3.2 1-12 Bills Street HAWTHORN

Reference No.:	N/A
Responsible Director	Nick Lund Urban Living
Authorised by:	Simon Mitchell Manager Strategic & Statutory Planning
Report officer:	Seuna Byrne Principal Planner Statutory Planning

STATUTORY PLANNING OFFICERS REPORT

Above: Marked up drawing identifying the areas where a reduction of the street wall height is recommended

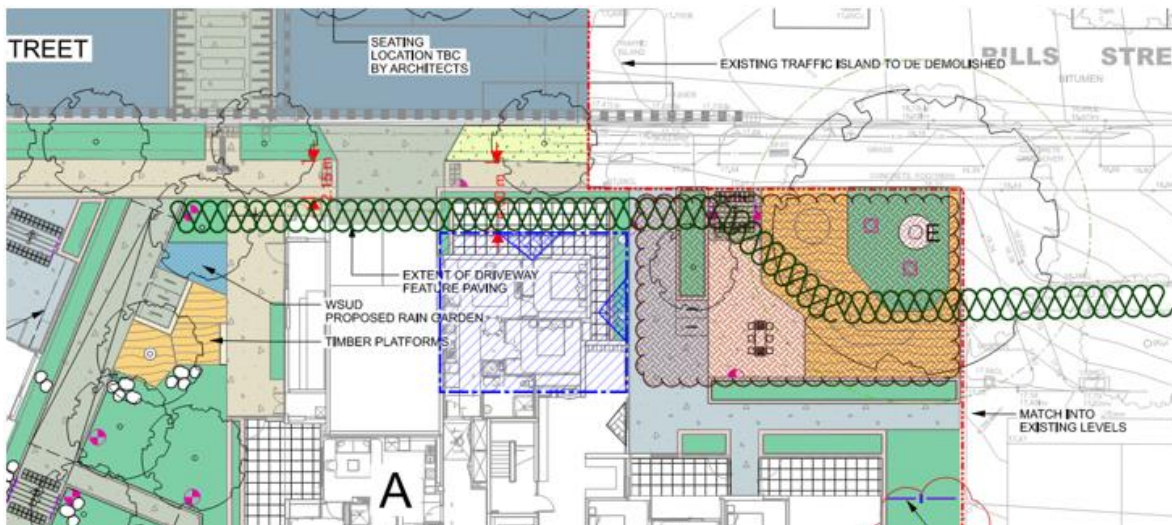
- The inclusion of a community facility/room into the precinct should be non-negotiable. It was part of the housing estate, and its loss is regrettable. The success of the 'arrival court' piazza, which Council's UDF conceived as the pulsating heart of the precinct, is largely dependent on the delivery of a community facility within the ground level of Building A. The community room should generally occupy the area of Apartment A-G02, with a 2.0m front setback to enable widening of the adjacent Bills Street footpath to 4.0m for its length as it continues to the public link connecting Bills Street with the reserve, between Buildings A and B (see diagram below).

Figure 12: extracted 3D renders of the proposal as seen in the views from the backyards of Nos. 5 and 7 Burgess Street.

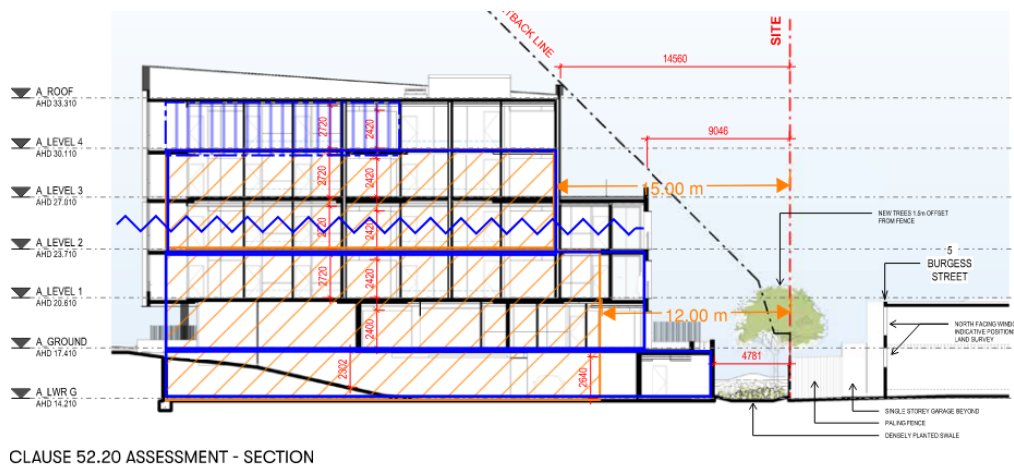
The impact on these neighbours would most likely be visual, as evident in the 3D renders in Figure 12 below. This effect is partly because of the building height and partly because of its massing and expression. A reduction in the height of the middle floors, potentially the deletion of the fourth level, and an increased level of mass modulation, e.g., more rebates and greater relief, should minimise the visual impact of this building.

Figure 14: a sketch extracted from the UDF communicating the vision for the precinct, which seeks to create a unique sense of place by capitalising on the synergies between the new community facility, the public square, the adjacent shops and the north-south spine linking to the Reserve.

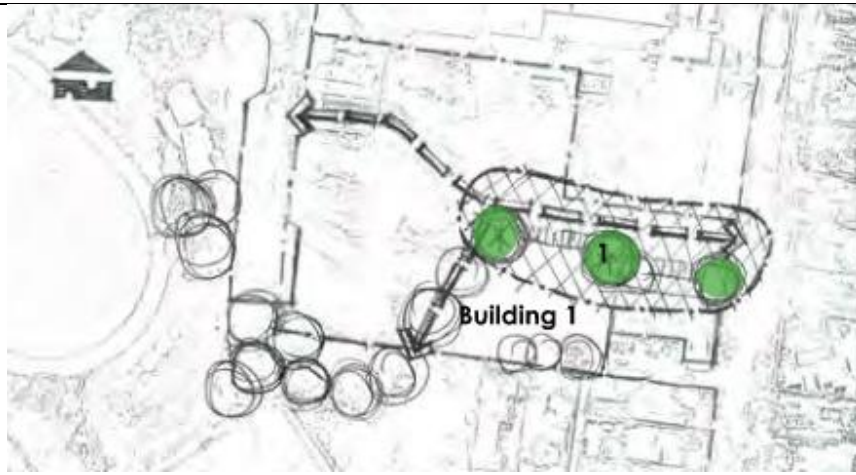
The UDF had envisioned that the community room that was part of the housing estate would be reinstated and play a pivotal role in any future redevelopments. It saw it expanding to be the centre of the new precinct, the beating heart of the revitalised area. Co-located with the public square/piazza and centred on the retained trees, the community facility would be imperative for building a sense of community and belonging among residents. In addition, the vision was that a wide pedestrian walkway would connect the two to the adjacent shops to the east and the North-South Spine/Corridor to the west, as well as connecting Auburn Road to Robinson Roads via the enhanced Bills Street avenue environment, as illustrated in the extracted sketch in Figure 14 below.

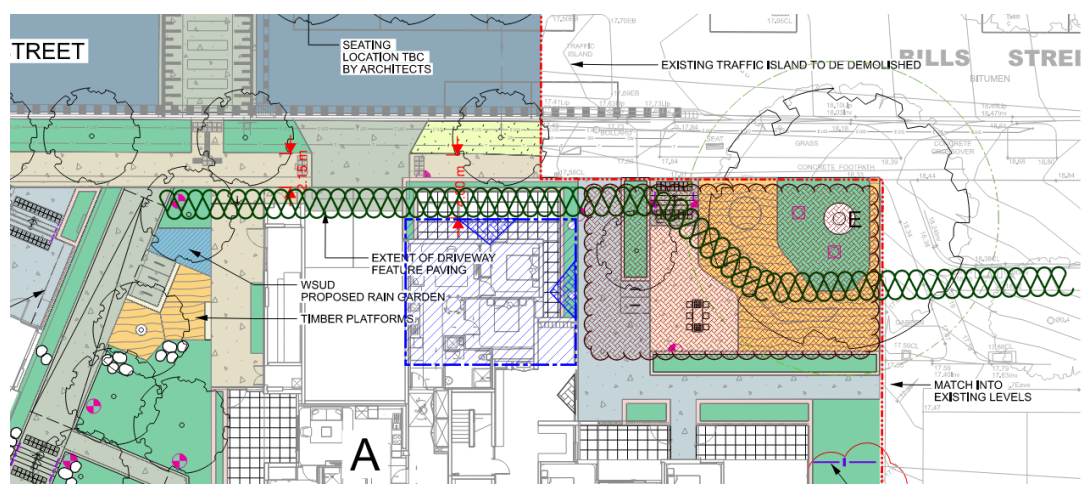
The inclusion of a community facility/room into the precinct should be non-negotiable. It was part of the housing estate, and its loss is regrettable. As explained above, its contribution to the new community, particularly the social housing residents, would be invaluable as it would help reconnect the displaced community and foster a spirit of comradery and belonging. If it is reinstated, the community facility should ideally be located on the ground floor of Building A to help revitalise the public square, as marked on the ground floor plan in Figure 15 below.

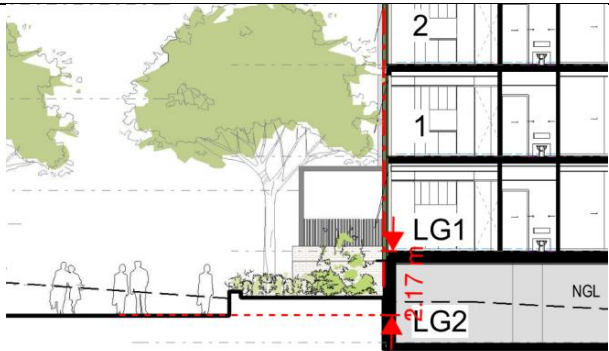
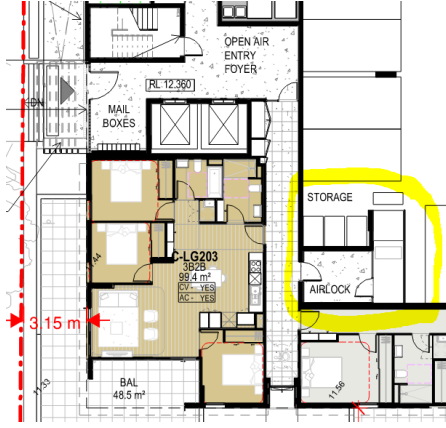
Standard	Assessment/comments	Complies
Car parking must be well lit and clearly signed.	<p>Details of internal lighting within the basement car parks is not shown on the plans.</p> <p>Details of directional signage is not shown on the plans.</p>	* Non-compliant (further information required)
The design of car parks must maximise natural surveillance and pedestrian visibility from adjacent buildings.	Other than the on-street spaces, no at-grade parking is proposed.	N/A
Pedestrian access to carparking areas from the street must be convenient.	Council's Urban Designer has identified concerns with the design of the building entry for Building C, from Bills Street. The entrance is too discrete, encircled by balcony and planter infrastructure associated with Apartments C-LG103 and C-LG104, and located some 2.17m above the proposed pavement level of the western end of Bills St. The layout of Building C and its interface with Bills Street needs to be entirely reconceived to provide improved pedestrian connections and activation of the public realm.	* Non-compliant (Building C)

<p>Above: Extract from Site Section 3, showing the pedestrian entrance to Building C sitting more than 2m above pavement level in Bills St</p>	
<p>Pedestrian routes through car parking areas and building entries and other destination points must be clearly marked and separated from traffic in high activity parking areas.</p>	<p>The Lower Ground 2 south-west entrance to the car park in Building C is circuitous and opens into a space encircled by storage cubicles. The airlock is also proximate to bedrooms in Apartments C-LG202 and C-LG203, which may be a source of disruptive noise. It is recommended the airlock be shifted further north and swapped with the storage spaces, locating it closer to the lift core/entry foyer.</p>  <p>Above: Extract from the Lower Ground 2 Floor Plan, showing the inconveniently located airlock entrance to the car park in the south-west corner</p>	<p>* Non-compliant (Building C)</p>

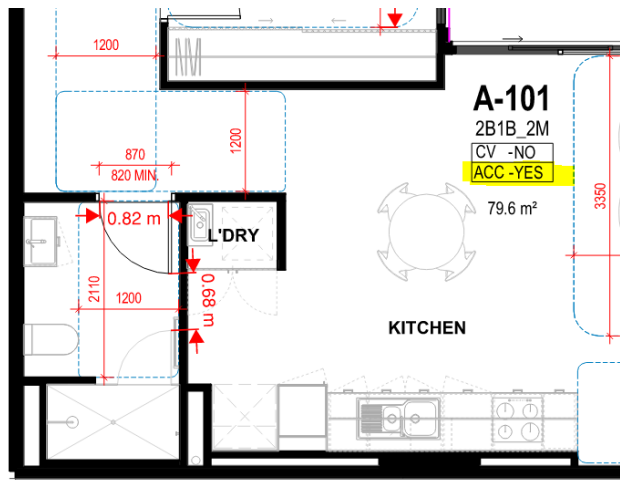
<p>requirements of either Design A or Design B specified in Table 7.</p>	<p>Above: Marked-up extract from the Lower Ground 1 Floor Plan showing the dimensions of the bathroom in Apartment A-LG01, which comply with some but not all of the requirements of Design B (the circulation area is not 2.7m long)</p> <p>A review of even the annotated, enlarged “typical” apartment layouts included in the package of plans from the architects shows erroneous statements of compliance with the standard. For example, Apartment A-101 is shown to be accessibility-compliant, yet the bathroom circulation area does not have dimensions that comply with either Option A or Option B (noting that because the bathroom door clear opening width is 0.82m, the layout should comply with Option B) because the circulation space is not clear of the bathroom door or shower door swing.</p>  <p>The floor plan for Apartment A-101 (2B1B_2M) shows a kitchen, a living area, a bedroom, and a bathroom. The bathroom has a door with a clear opening width of 0.82m. The circulation area is marked with dimensions 1200, 870, 820 MIN, and 1200. The kitchen area is marked with dimensions 2110, 1200, and 890. The overall dimensions of the apartment are 3350 by 79.6 m². The accessibility status is listed as CV -NO and ACC-YES.</p> <p>Above: Extract of Apartment A-101 from the “Typical Apartments” layout plans, which demonstrates the bathroom does not meet all of the requirements of either Option A or Option B, despite being labelled “ACC-YES”, meaning compliant</p>

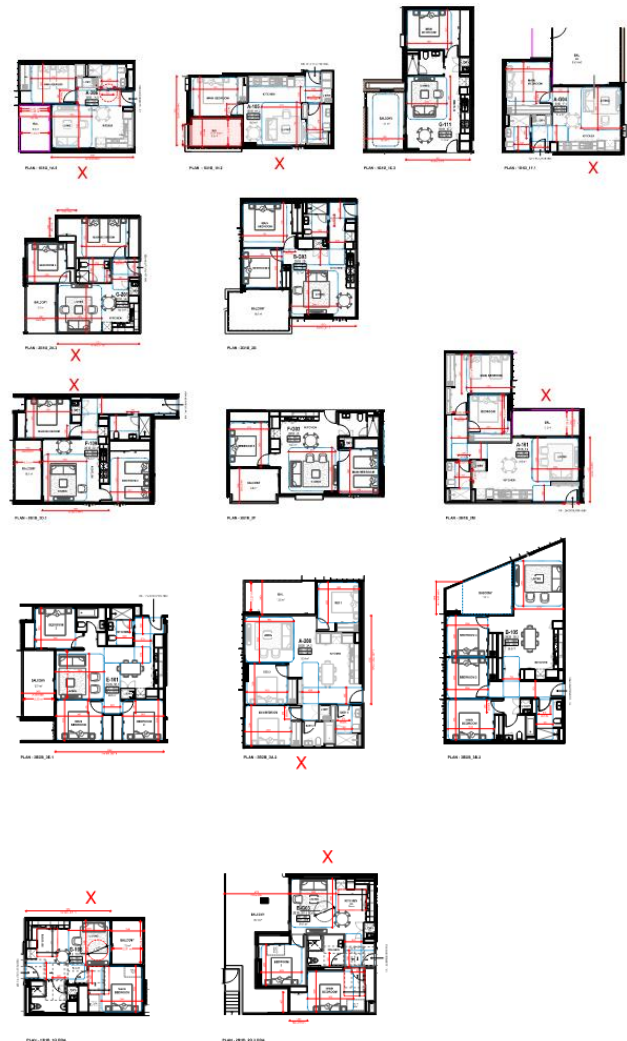
Of the 14 “typical” apartment layouts provided in an enlarged, annotated format, nine have living areas which are non-compliant. If these “typical” apartment layouts are genuinely a representative sample of apartments in the development, it is estimated 64% of apartments have non-compliant living areas. This is considered to be a failure to deliver liveable, functional homes.
